10/9/25 - 103E discussion

From: Sonia, Sonia (Consultant)
 Sent: Friday, May 13, 2022 8:59 AM
 To: Abraham, Ryan <ryan.abraham@acem.com>
 Cc: Gwyneth, Jon <jon.gwyneth@acem.com>
 Subject: RE: EXTERNAL FW: 405 BR - 405/103E Widening Follow-Up on BDM Section 4 Requirements

3/19/25 - Jason and Mohammad S.

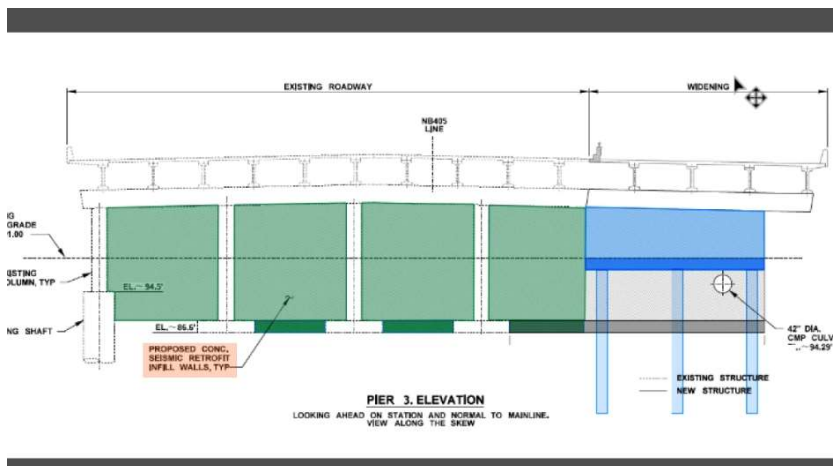
12 micropiles - how would the culvert come through? Casing?
2 rows of 6 - spacing 6' diameter

2 asks - place footing above culvert?
Separate the bridge

History - RFP concept/language

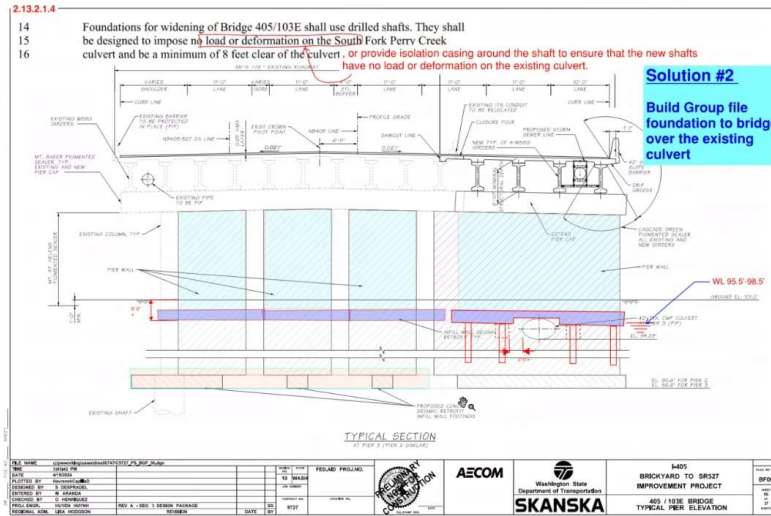
Widening - have to retrofit the footings

New footing - differential settlement

DON'T WANT A NON-STANDARD SYSTEM

NOT equal value

HAVE TO CONNECT - coupling beams - that would be where the plastic hinge would be located

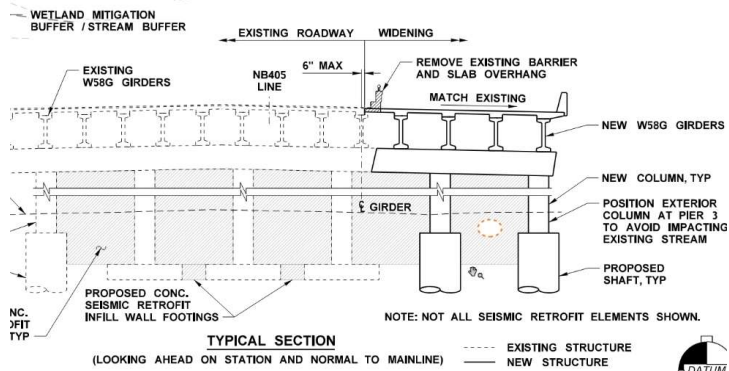
EVERYTHING IS NO...

Because - recovery - ductility limited to 2.5 - not going to need to inspect this after a seismic event

If culvert is BELOW top of shaft - no infill wall is needed below the top of shaft

EXISTING STRUCTURE DEPTH

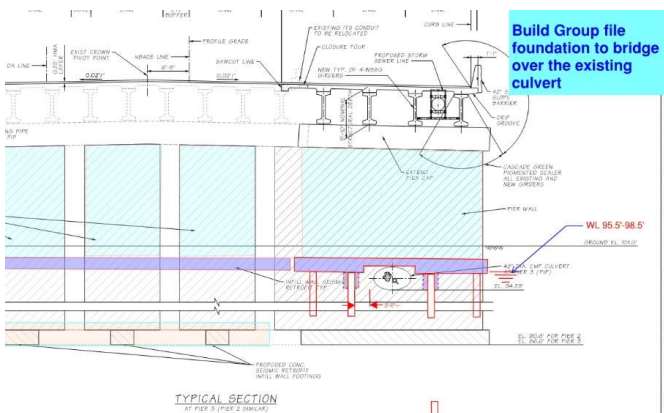
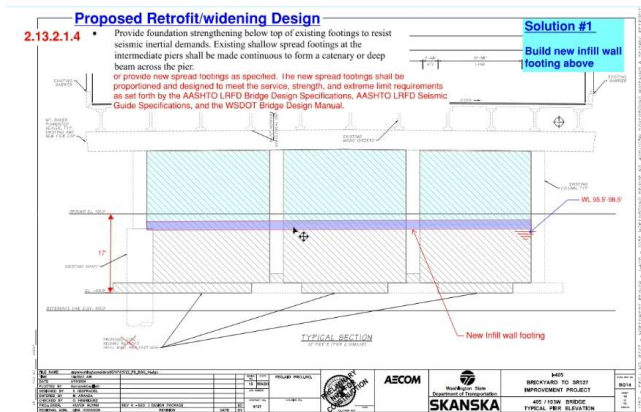
- How to protect the existing culvert

Solution #2

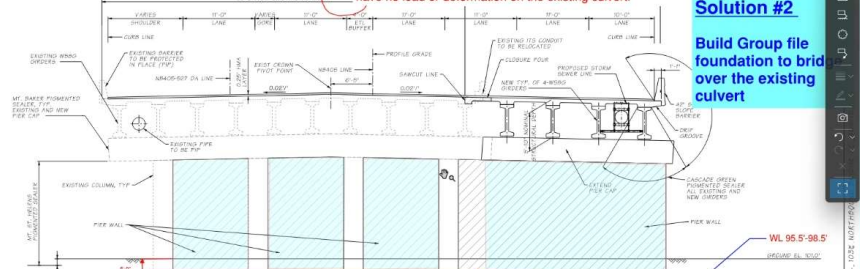
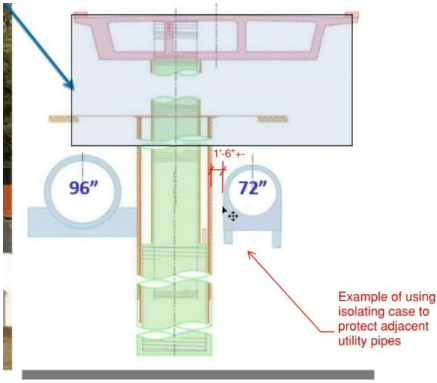
Build Group file foundation to bridge over the existing culvert

ISOLATION CASING TO MINIMIZE IMPACT TO CULVERT

Any shifting or deformation of shaft would occur in the casing and not impact the culvert

Advantages of DBIC:

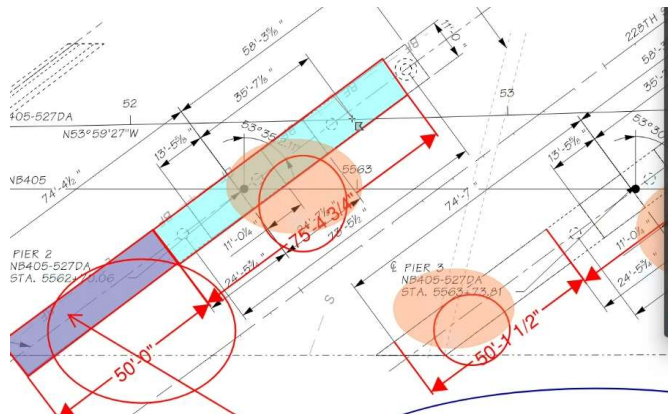
- Minimizing dewatering
- Reducing excavation and potentially eliminating temporary shoring
- Short construction time
- Minimizing traffic disruption
- Minimizing environmental impact
- Better Seismic Performance (no underground plastic hinges)
- Existing Culvert Well Protected in a Conservative Way

Probably do some open excavation

Build new footing - cap ABOVE original Footing
Static load
